Re: **Agency Response**
Shell-branded Service Station
610 Market Street
Oakland, California
Incident # 98995750
Cambria Project # 244-0594

The January 2, 2002 ACHCSA letter summarizes Cambria's December 19, 2001 *Soil Vapor Extraction Pilot Test Report and Investigation Work Plan* and approves the scope of work described. The letter also recommends additional sampling locations near a former dispenser island and within the current tank pit, and requests written comment prior to implementation of the approved subsurface investigation. Our responses follow excerpts from the ACHCSA letter, as indicated below.

Proposed Monitoring Well and
Soil Boring Location Map

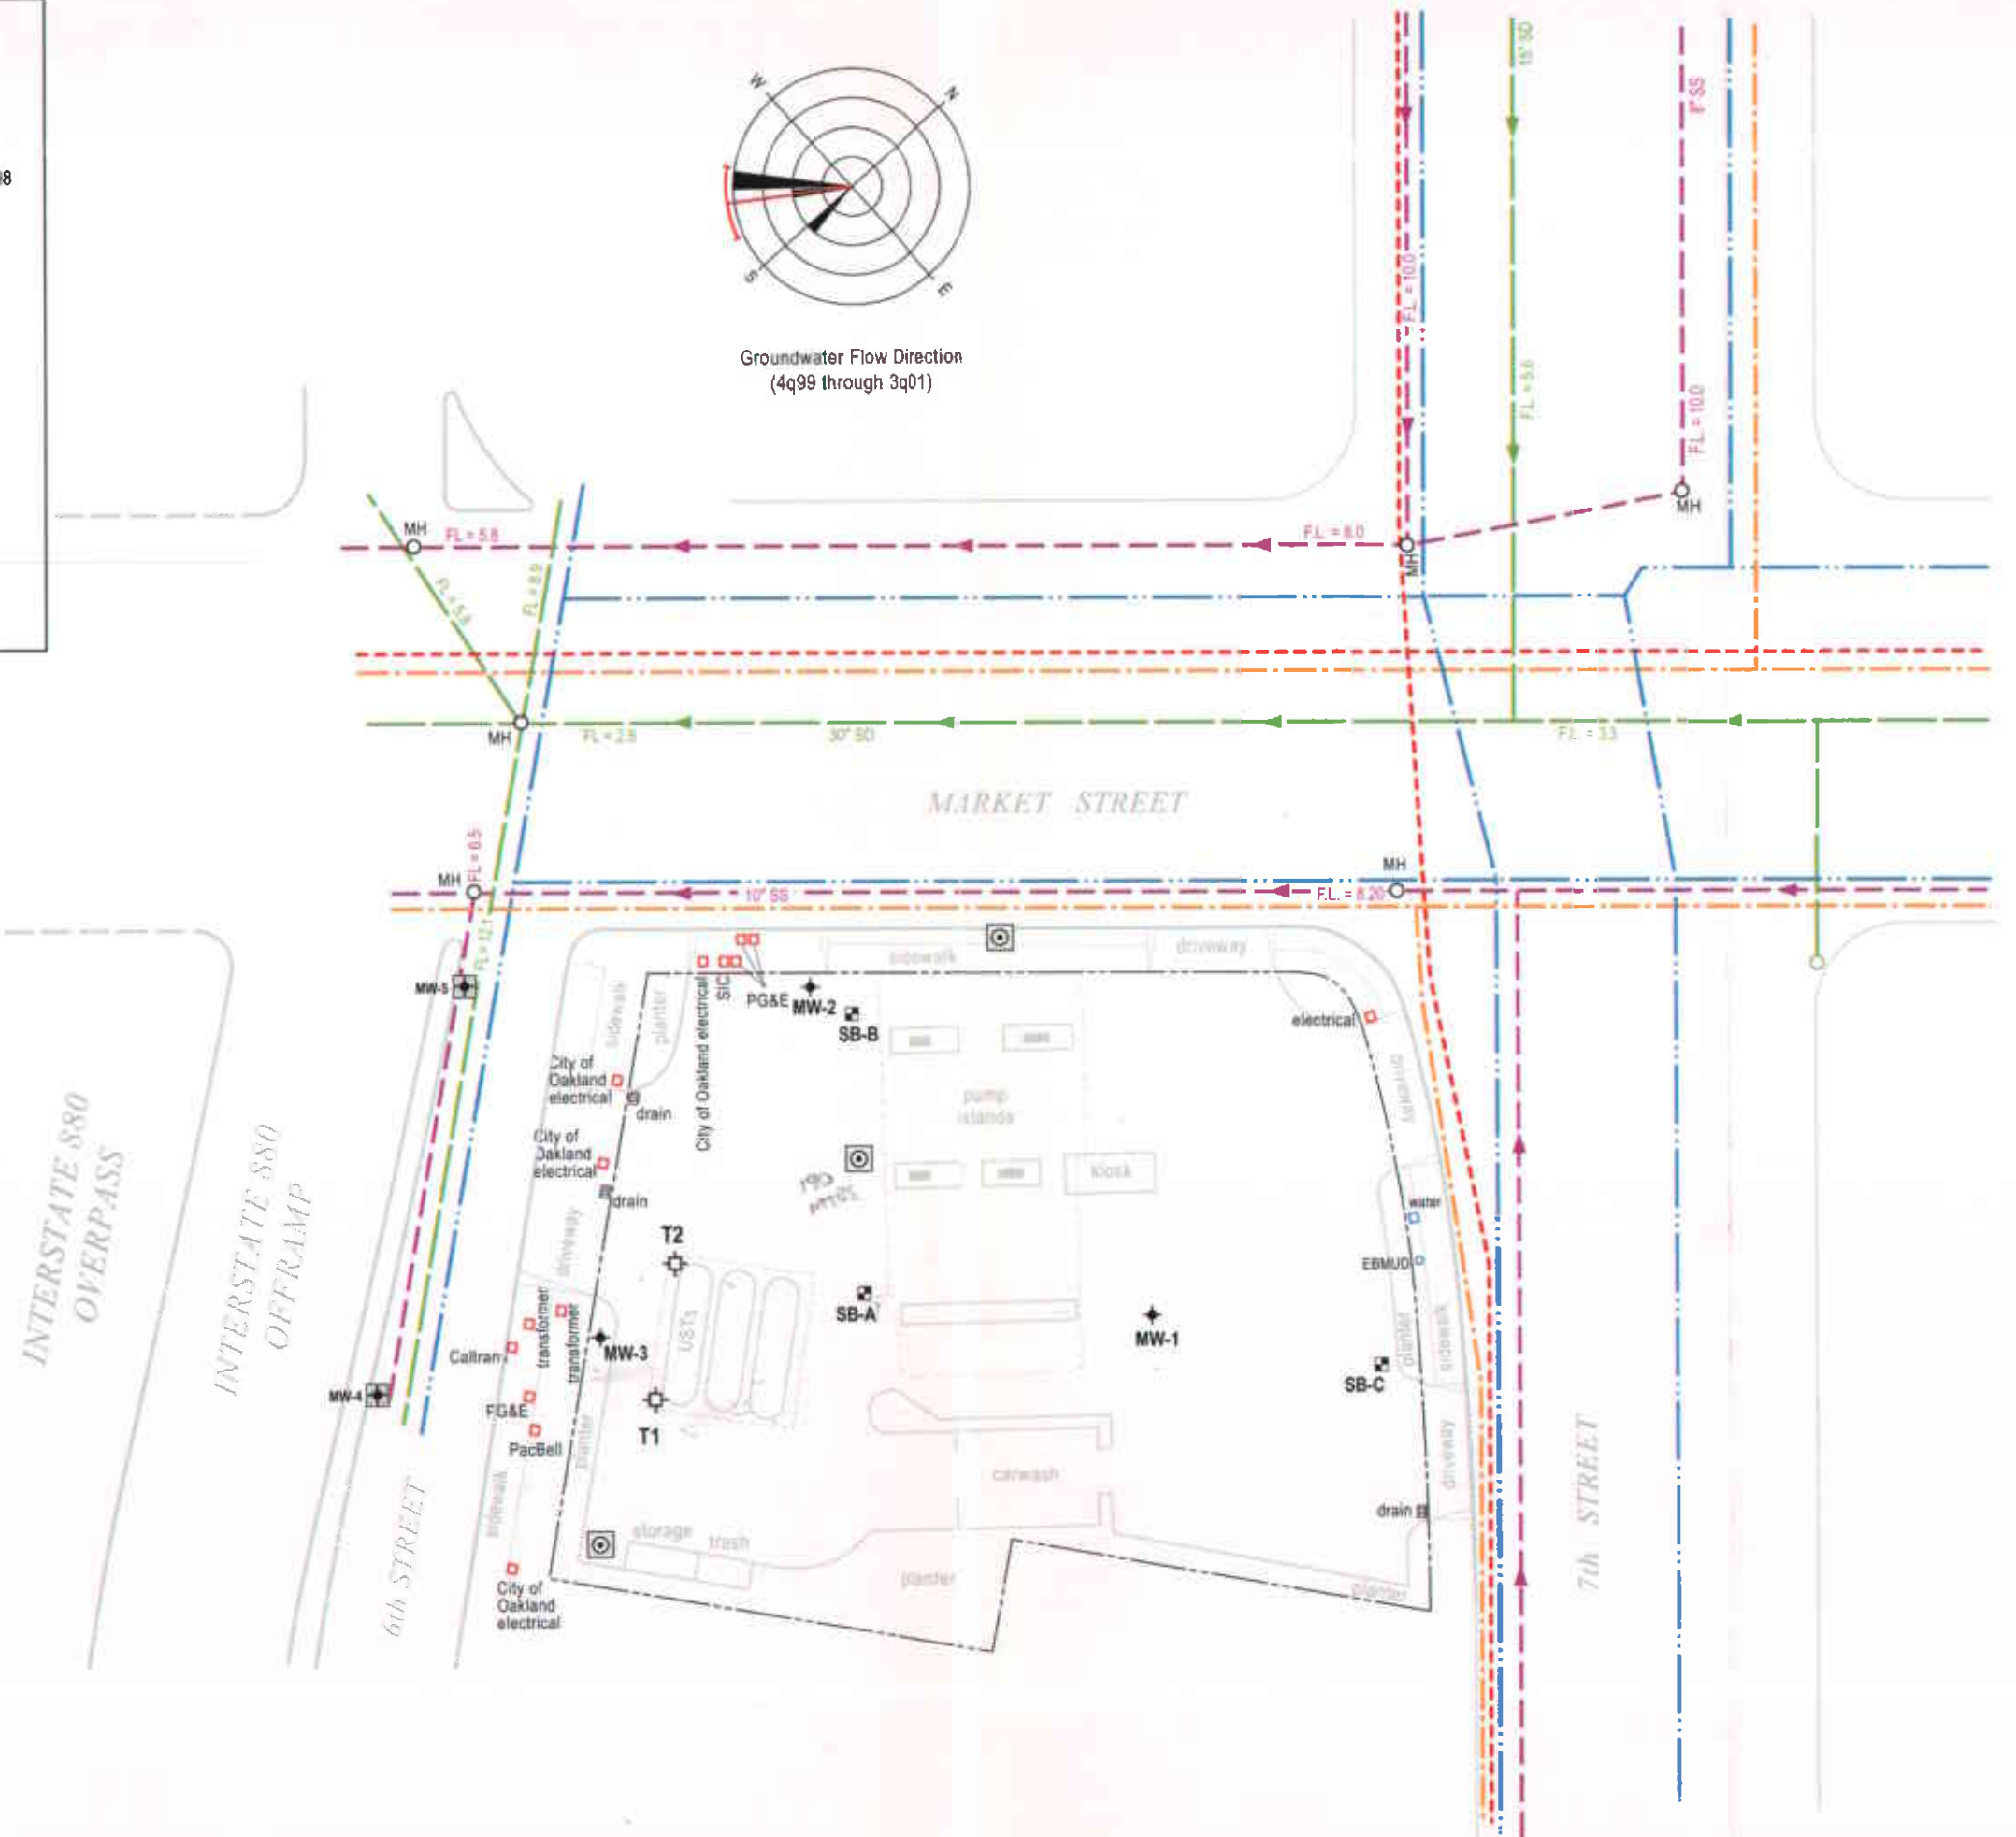
To estimate the extent of MTBE release our office recommended the installation of a well near SB-A. Cambria, however, does not see this need since over-excavation of the former dispenser area near SB-A was successful in removing TPHg and BTEX. Unfortunately, MTBE was not analyzed in soil samples from the over-excavation. The grab groundwater samples from SB-A reported 14,000 ppb MTBE and 1.8 ppm MTBE in the soil sample from 13.5' bgs.

Whether or not an additional well is installed near SB-A, enough data must be provided to determine the area extent and iso-concentration contour of the TPH and MTBE releases.

Groundwater beneath the pit must be characterized and it must be determined if such contamination is a source of hydrocarbons detected in the backfill wells.

The reasoning stated in our December 19, 2001 report for not installing a well near boring SB-A (Figure 2) differs somewhat from your summary. Our reasoning was that a monitoring well located in that area would not be downgradient of any remaining potential sources and would

therefore not be necessary. Monitoring well MW-1 adequately assesses groundwater concentrations in the upgradient direction of the underground storage tank (UST) pit, and since any possible source (the former piping and dispensers or impacted soil) between the UST pit and well MW-1 has been removed or over-excavated, an additional well between the UST pit and well MW-1 would be redundant. Boring SB-A was installed after the fuel-related equipment and impacted soil were removed from the area. There is no reason to believe that methyl tertiary butyl ether (MTBE) concentrations in the vicinity of SB-A have increased or will increase in the absence of any remaining source. The extent of the MTBE release can be adequately determined using the SB-A grab groundwater and soil sample data, the continued quarterly monitoring groundwater samples, and data from the borings and monitoring wells proposed in our December 19, 2001 report. In particular, we believe enough data will be obtained to provide isoconcentration contours of the MTBE and total petroleum hydrocarbon as gasoline plumes.

As stated above, Cambria believes that the area extent of MTBE can be determined without the installation of a monitoring well near boring SB-A. Cambria believes that the borings and monitoring wells proposed in the December 19, 2001 report coupled with data from previously installed borings and monitoring wells will be adequate to determine the extent and isoconcentration contours of the TPH and MTBE plumes at the site. As requested in your November 5, 2001 letter and stated in our December 19, 2002 report, isoconcentration contours will be completed and reported following the subsurface investigation conducted at the site.

Characterizing groundwater directly beneath the UST pit is impractical and unnecessary. Groundwater beneath the UST pit is adequately represented by samples from well MW-3 located immediately downgradient of the UST pit. As shown by the rose diagram presented on Figure 2, groundwater flow direction is consistently southwest, and well MW-3 is located 10 feet southwest of the UST pit. The difficulty and expense of trying to sample groundwater a few feet closer to potential source is unjustified.
